Applicant Response

In response to, 1c. Interpretation/Diagnosis – Understanding (comment pg. 12)

FIGURE 1

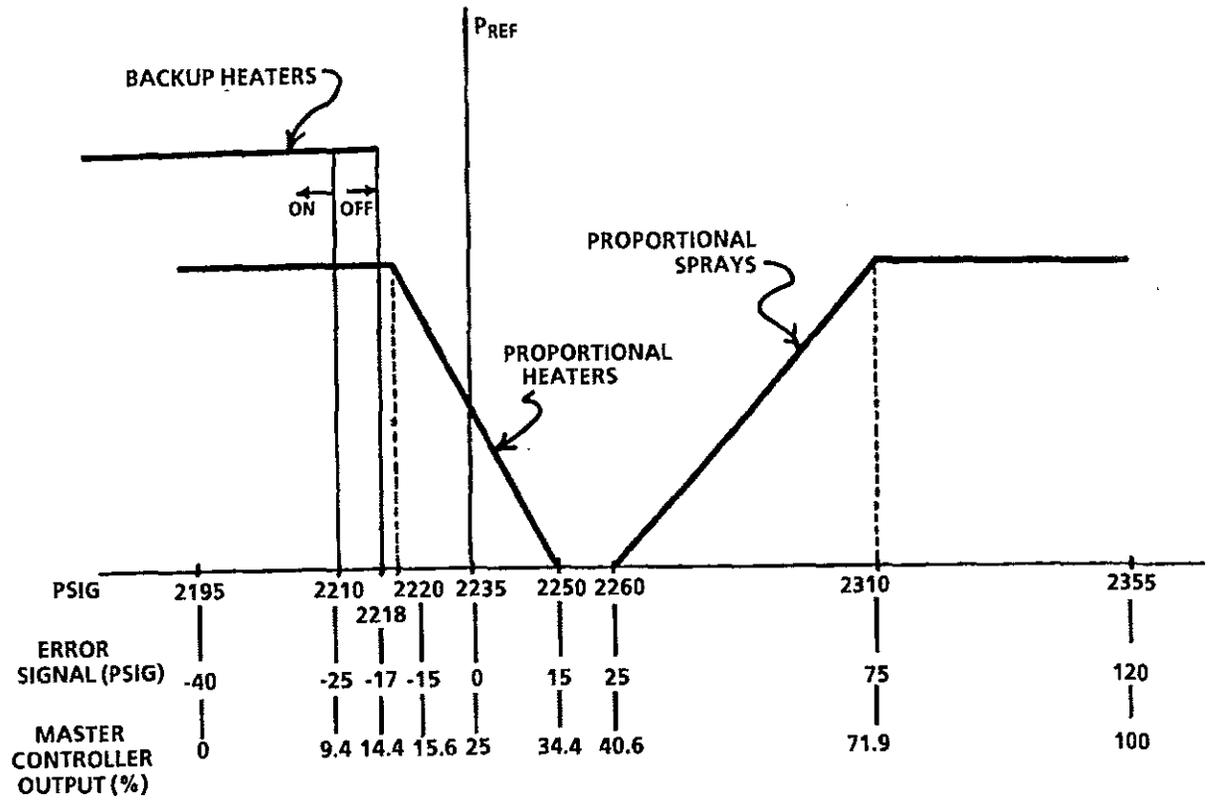
Pg. 12 response:

Carla (SRO) directed me (RO) to place heaters in Auto per step C8.b. I discussed with Carla that this would take pressure out of the band established in the continuous action step C4 due to pressurizer level being greater than 5% of program level which would cause all of the backup heaters to energize:

After a discussion Carla instructed me to maintain pressurizer pressure IAW the continuous action step while allowing pressurizer level to return to program. Pressurizer level was out of band due to a previous failure and subsequently placing excess letdown in service. Pressurizer level was trending slowly to program at this time.
